To: Gerry Bowen
Papio-Missouri River Natural Resources District (PMRNRD)

Date: January 10, 2011

Subject: Preliminary Observations and Recommendations for Repairs to Elkhorn River IPA

Figure 16. Recommended stabilization measures for Field Site 2.

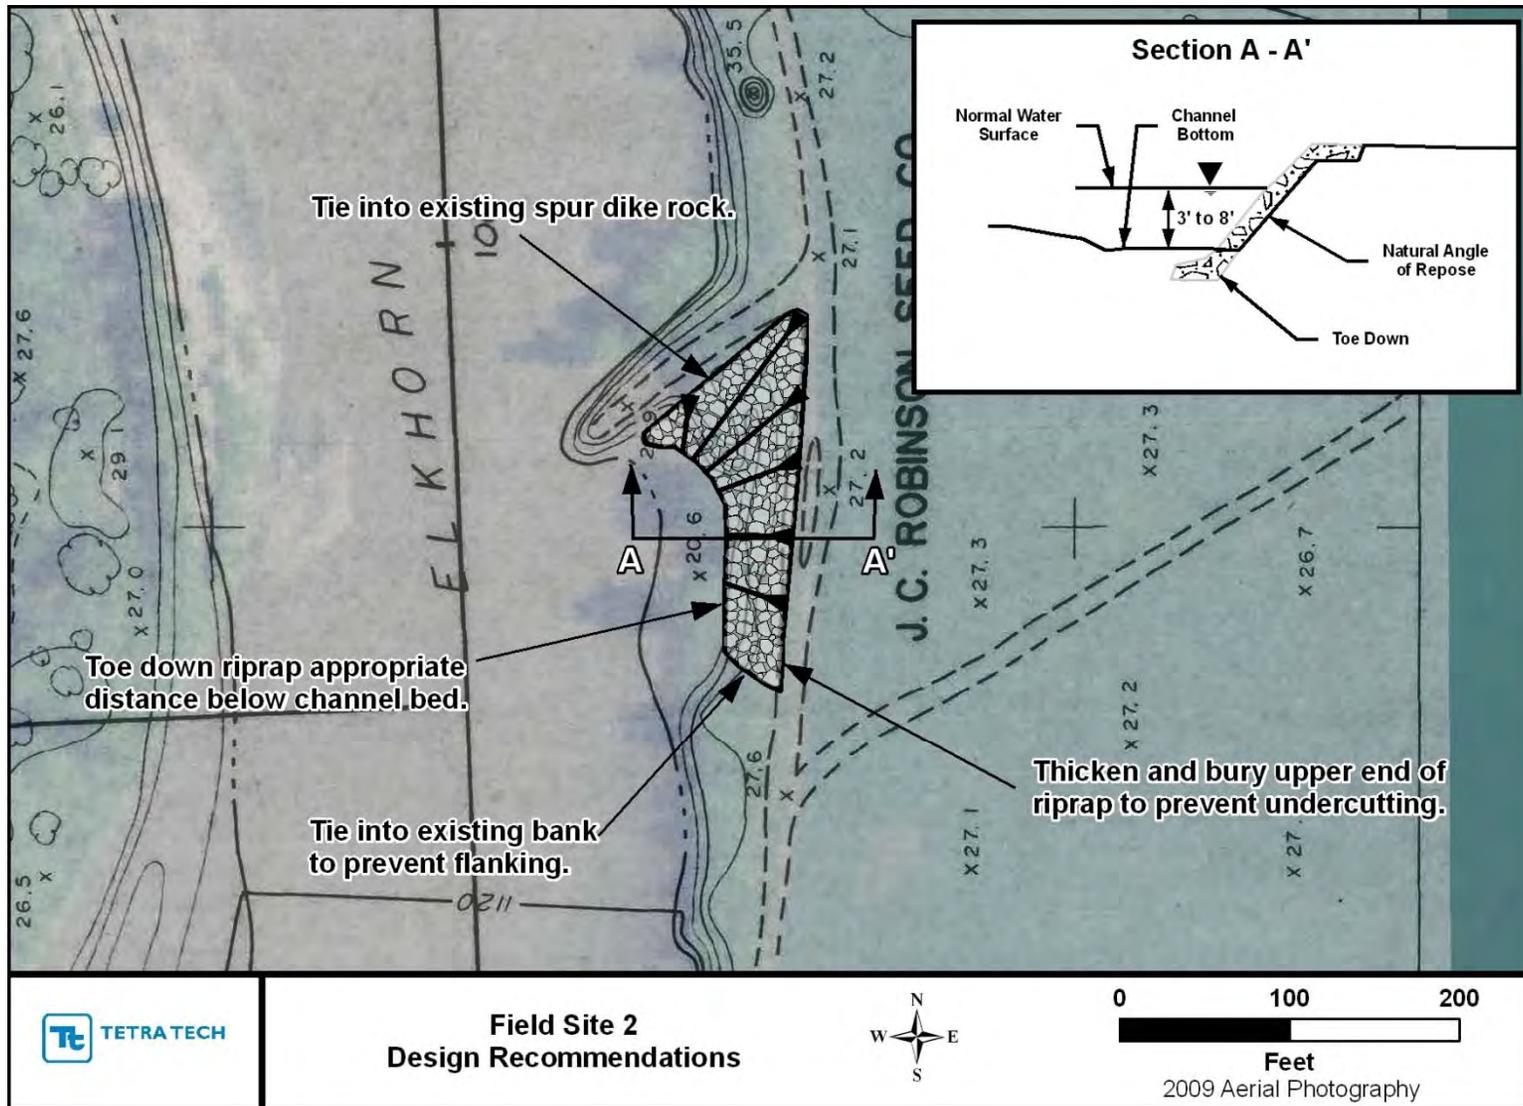
Field Site 2 is located near the middle of a left-bank jetty field that was constructed prior to the IPA project (**Figure 12**). The jetty field appears to be very stable and is functioning as intended (**Figure 13**). The problem area occurs just downstream from a large jetty near the middle of the jetty field where surface runoff has created a headcut and gully that is eroding back into the adjacent field (**Figures 14 and 15**). Sufficient information is not available to be certain about the source of the runoff that has caused the gulying, but it appears to have developed during the 2010 high-flow event, most likely due to overbank flows returning to the channel. Since it has developed in the low area/minor swale in the overbank area, both future overbank flows and local runoff from the adjacent field will continue to erode and expand the gully. Although expansion of the gully will damage the field, it is unlikely to endanger the stability of the overall dike field and bankline in this area; thus, this problem is not likely to affect the overall stability of the IPA reach.

2. Construct rock grade-controls or a rock chute in the head cut from the top to the base of the bank, and formalize a drainage swale that would connect to the upstream end of the protection to insure that future flows do not flank the installation.

The first solution would be problematic if the erosion is due to overbank flows, because the embankment would potentially block flows from returning to the channel at this location, essentially pushing the problem farther downstream. The first solution would also require additional grading of the area in order to concentrate the overland flows and provide adequate depths and prevent blockage at the drop inlet. The second solution would work regardless of the runoff source, but care would need to be taken in the placement of the revetment to avoid local scour around the protection that could make the problem worse.

Given the available topography, the second solution is recommended. For this solution, the existing bank would be graded to develop a more defined drainage swale and then protected by the placement of rock riprap of an appropriate size along the surface (**Figure 16**). It is also recommended that a granular filter be placed under the rock rather than filter fabric, which has caused rock to launch in nearby locations. Care will need to be taken to tie the upstream and downstream ends of the revetment into the existing spur dike rock and channel bank, respectively, as well as to continue the placement of rock down to an appropriate toe-down depth below the channel to protect against local scour. The layer of riprap should extend up to the top of bank, where it should be thickened and keyed into the bank to prevent overtopping flows from undercutting the revetment.

Figure 26a. Construction plans for the middle portion of IPA Site 12 overlaid on the September 2009 aerial photograph. Also shown are the October 2000, October 2004 and September 2009 banklines showing the ~100-foot bank migration at Field Site 5.

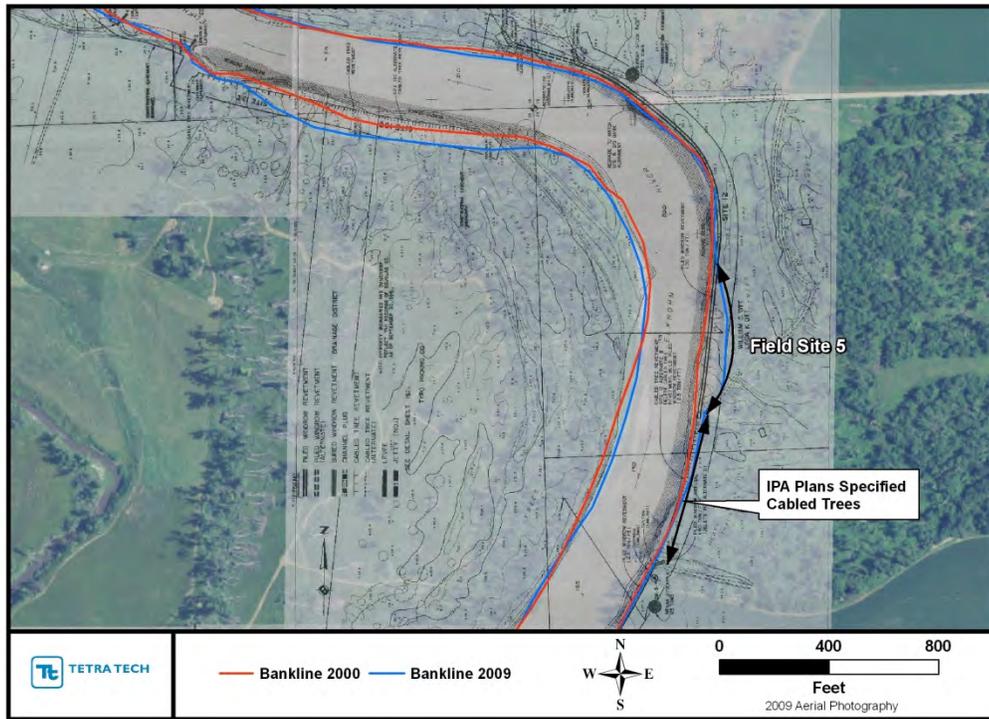
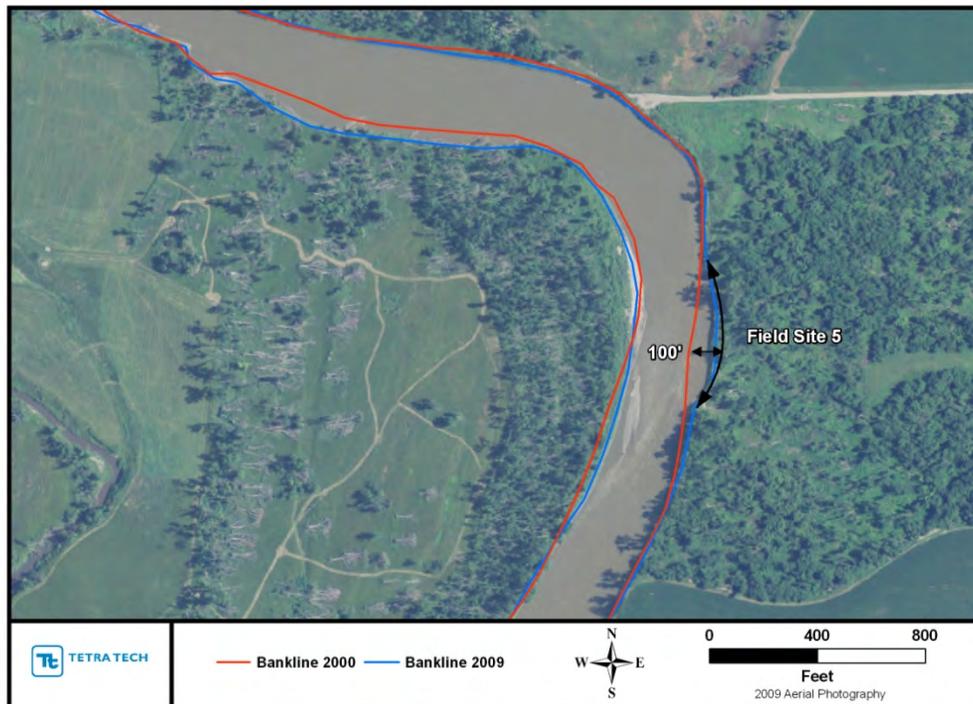
Field Site 5 is located on the left bank near the middle of IPA Site 12 where the bankline has retreated laterally by up to 100 feet over a length of approximately 600 feet since October 2004 (**Figures 26a and 26b**). Some rock is still present at the base of the bank, and concrete rubble has apparently been added to the site since the original construction (**Figure 27**). The IPA plans called for piled windrow revetment from approximately the downstream end of Field Site 5 through the bend upstream from the site. The construction plans also called for cabled-tree revetment for about 550 feet immediately downstream of Field Site 5, but windrow revetment was placed in lieu of the cabled trees (Table 1, Note 8). The portions of the site up- and

downstream from Field Site 5 appear to be in good condition, but Field Site 5 is unstable and eroding, with significant gaps in the existing rock/concrete rubble protection. The overbank area along this site consists of moderately thick woods. If continued lateral erosion into the wooded area is considered to be a problem, it may be possible to check the erosion with additional windrow revetment, applied at a rate of 2.5 to 3.0 tons/foot. Before such additional rock is installed, however, it would probably be prudent to study this area in more detail, including evaluation of the construction notes, to gain a better understanding of why the indicated bank erosion has occurred to insure that the recommended fix is, in fact, appropriate.

Figure 28a. Construction plans for the cabled-tree revetment at IPA Site 13C (Field Site 6) overlaid on the September 2009 aerial photograph. Also shown are the October 2000, October 2004 and September 2009 banklines.

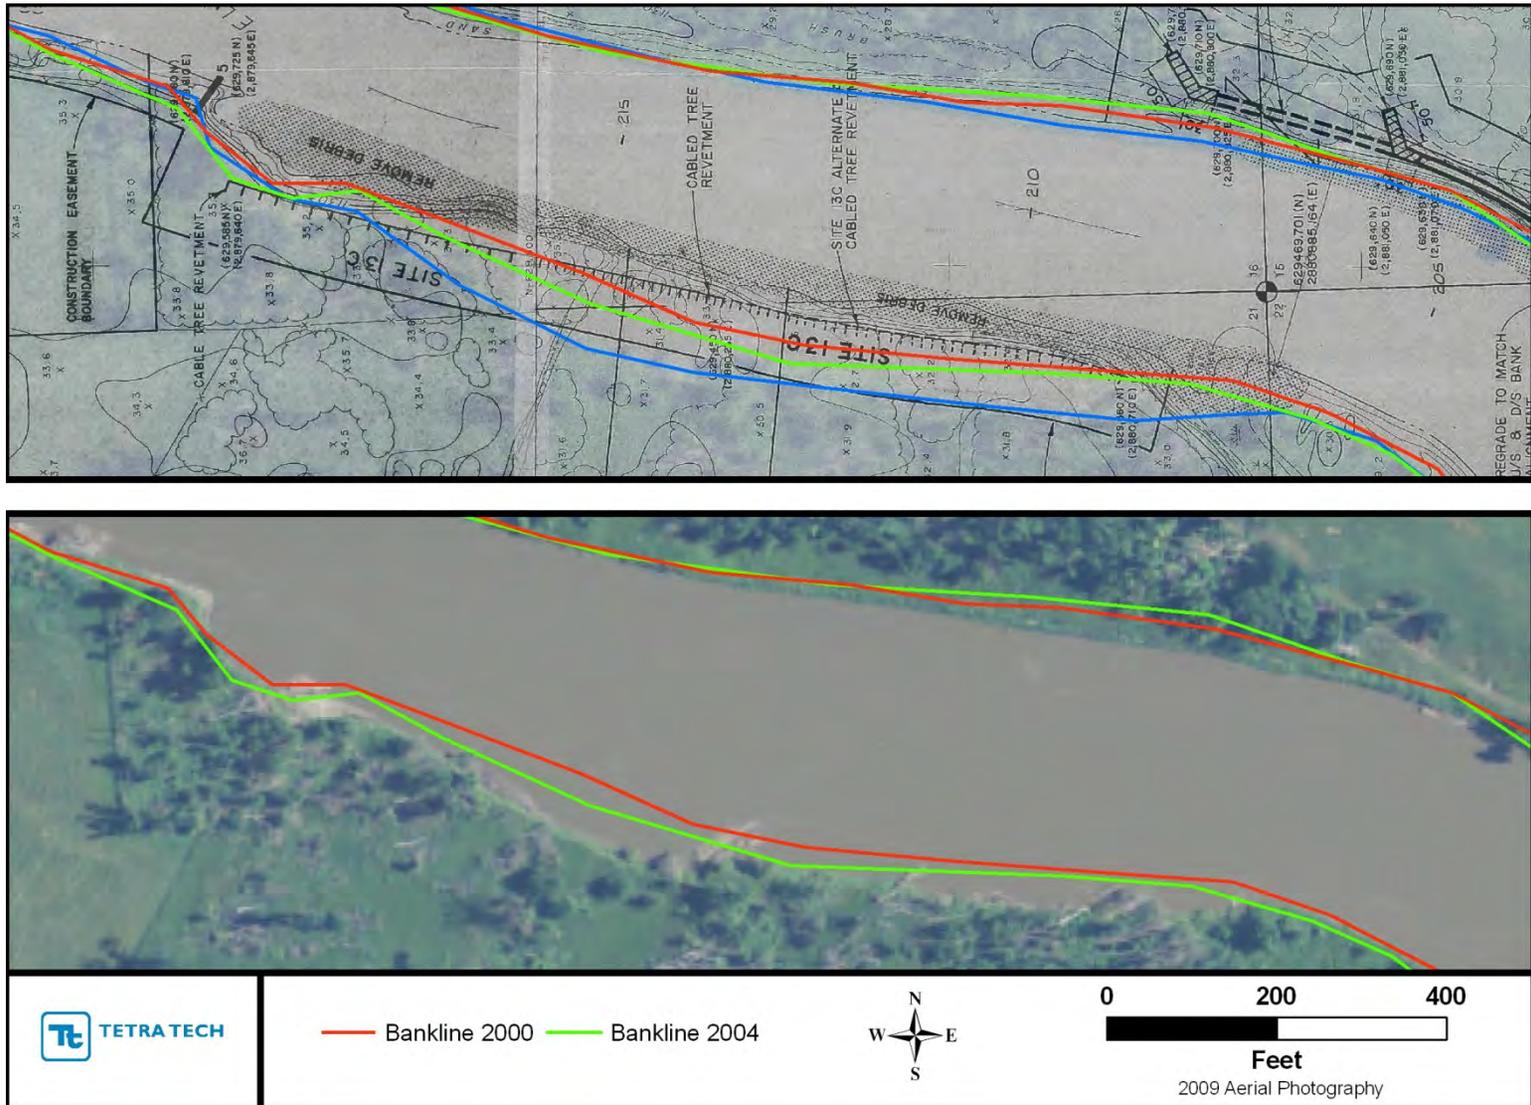
Field Site 6 is an approximately 1,400-foot long reach of eroding right bank where cable-tree revetment was installed as part of the original IPA project (Site 13C) (**Figures 28a and 28b**). The bankline along this site is quite unstable, including significant areas of undercut, slumping banks (**Figures 29 through 31**), and it migrated laterally by over 110 feet in some locations between construction of the original project and the September 2009 aerial photograph. The June 2010 aerial photograph indicates additional lateral erosion at this site of up to 20 feet in some locations. The overbank area at this site is sparsely to moderately vegetated with large trees. If continued lateral erosion into this area is problematic, the erosion can be checked with windrow revetment applied at a rate of 3.0 tons/foot.

Figure 37. Recommended re-alignment of bankline at Field Site 8 and typical cross section of the rock riprap that should be placed along the realigned bank.

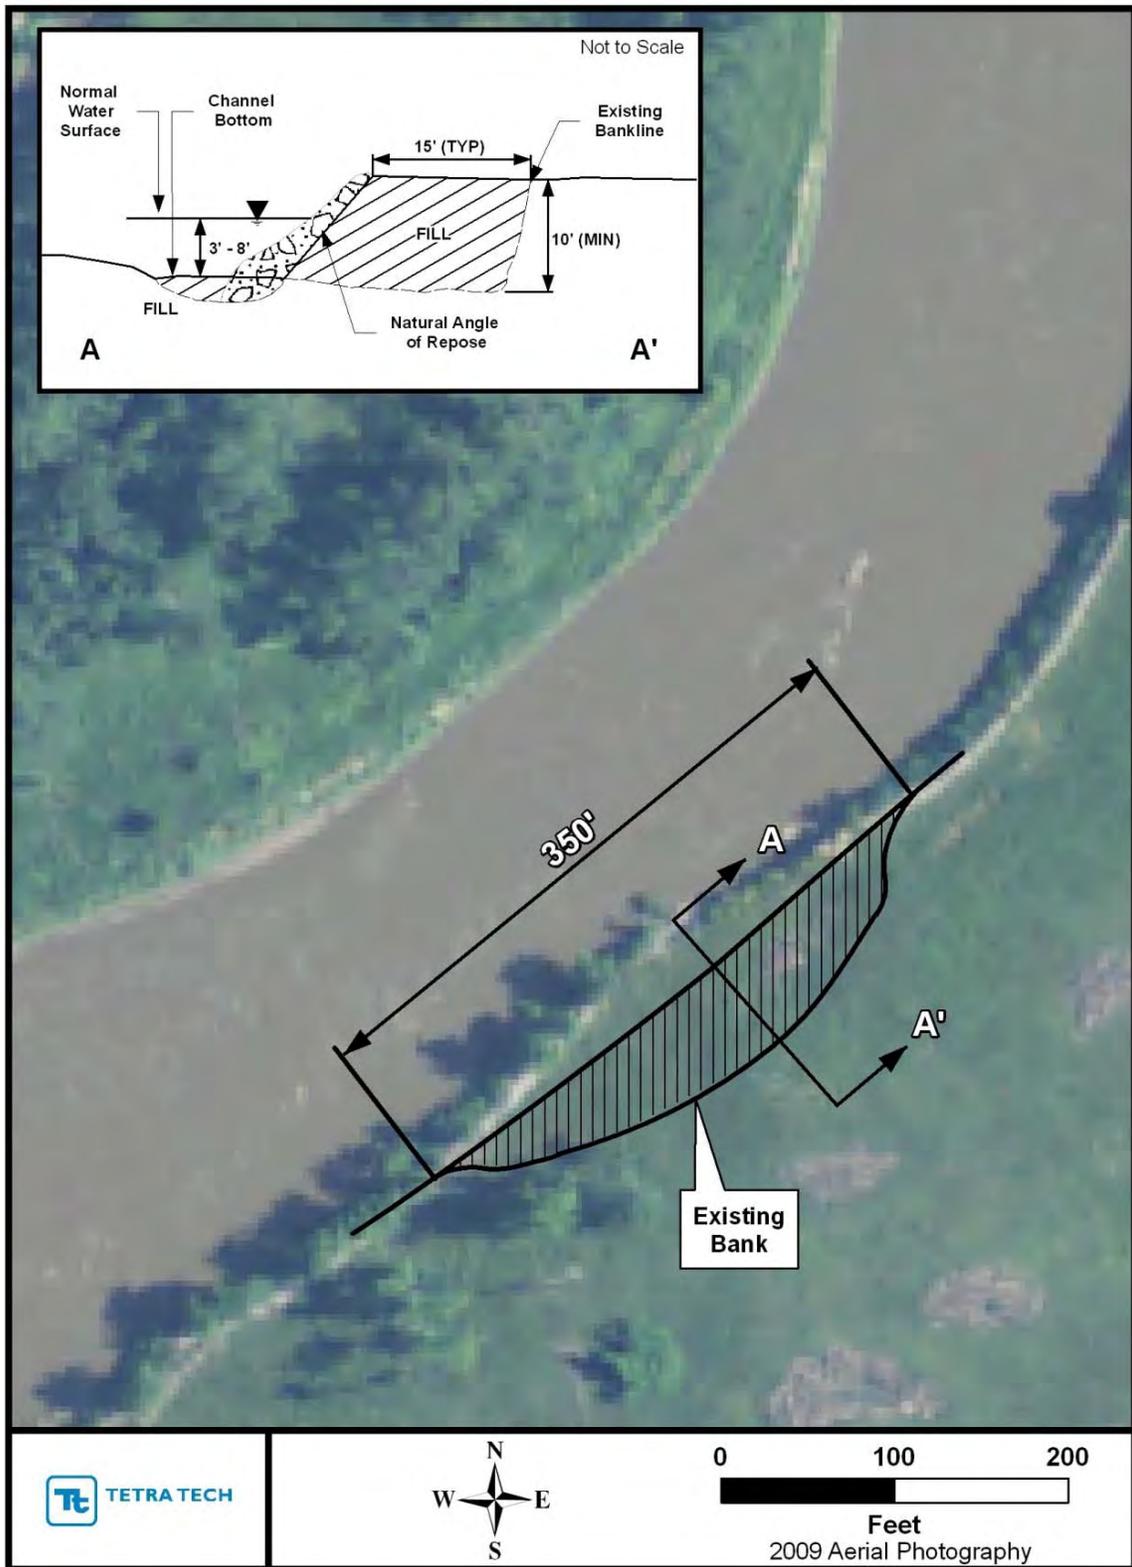
Field Site 8 is an approximately 300-foot long scallop that has developed in the left bank just downstream from a pre-existing rock spur located at the downstream end of the windrow revetment for Site 13B (**Figures 34 and 35**). The bankline at this location retreated into the overbank by nearly 80 feet downstream from the rock spur. The IPA construction plans called for cabled-tree revetment for approximately 1,000 feet downstream from the rock spur. The cabled-trees were not installed during the original construction, but windrow revetment was placed in this area in the late 1990s (**Figure 36**; Table 1, Note 16). With the exception of the scalloped area, the remainder of the bankline appears to be relatively stable at the present time.

Recommended repairs at Field Site 8 include realigning the bankline to eliminate the scallop, and placement of appropriately sized rock riprap on the realigned bankline (**Figure 37**). The length of the realigned bankline would be about 350 feet, and the area that would need to be filled between the existing and new bankline is about 17,000 ft². Assuming a bank height of 12

feet, based on the topography in the IPA plans, plus approximately 5 feet of local scour on the outside of the bend, a total fill volume of about 7,600 yd³ would be required.

Figure 40. Construction plans for IPA Site 13B overlaid onto the September 2009 aerial photograph. Note that windrow revetment has been installed at the upstream end where the plans call for cabled-tree revetment.

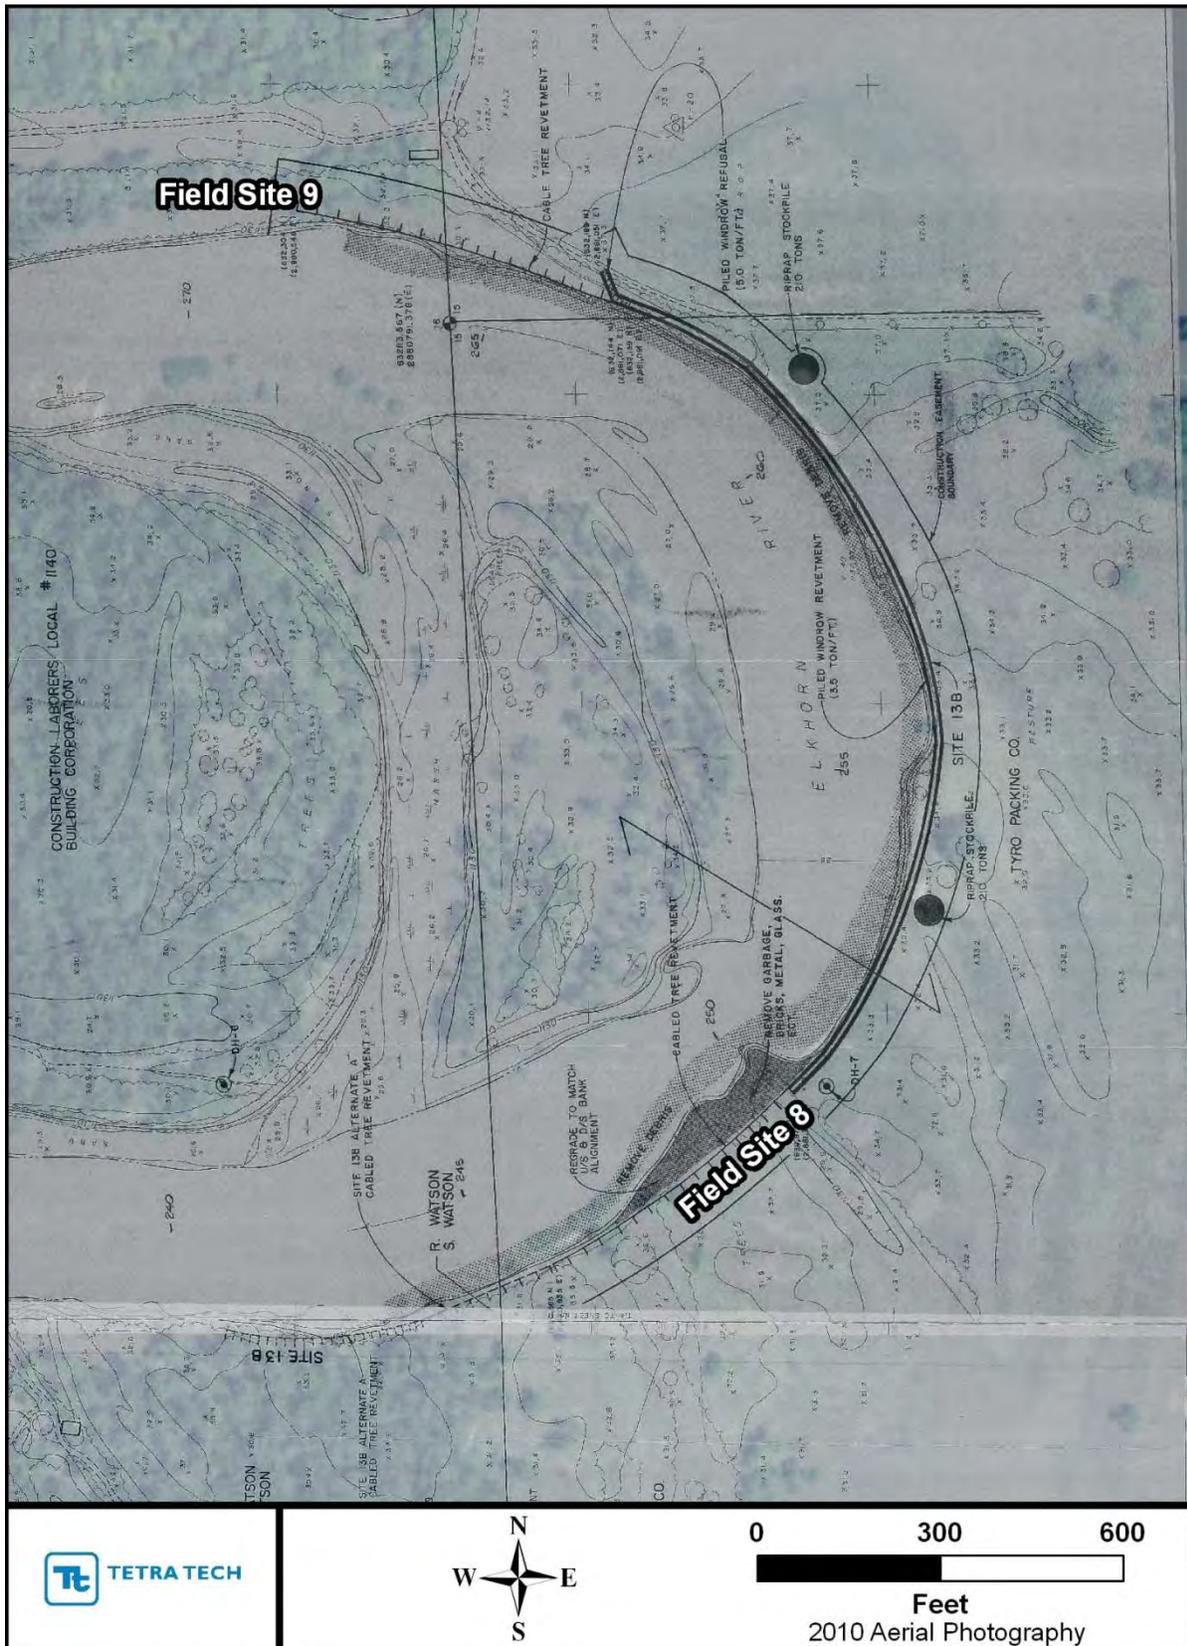
The IPA construction plans for Site 13B called for the piled windrow revetment to end about 300 feet downstream from the edge of the existing wooded area, with about 540 feet of cabled-tree revetment extending upstream from the end of the windrow (**Figure 40**). The cabled-trees were not installed; however, windrow revetment was placed in this part of the site at some point either during or after construction of the IPA (**Figure 41**). This portion of the site is also in good condition and is functioning as intended. A modest amount of bank erosion is now occurring in the approximately 300-foot reach just upstream from the existing rock (**Figures 41 and 42**). Woody debris is currently providing some protection for the site, but continued erosion is possible. A large woody debris jam has formed along the right bank just upstream from the site that appears to be constricting high flows against the left bank at Field Site 9 (**Figures 43 and 44**). A similar, but somewhat smaller, debris jam, was present about 400 feet downstream from the current location as late as 2004 that may have contributed to the erosion tendencies at the upstream end of IPA Site 13B (**Figure 45**). The bankline at Field Site 9 has migrated laterally into the wooded area by up to 50 feet in some places since October 2004.

While Field Site 9 is not in a critically unstable condition at the moment, it should be monitored after future high flows, and the windrow revetment extended upstream at an application rate of 3.0 tons/foot, if necessary. Although the debris jam likely provides habitat value, removal of at least the part that projects into the main current would also relieve some of the erosional pressure on the left bank.
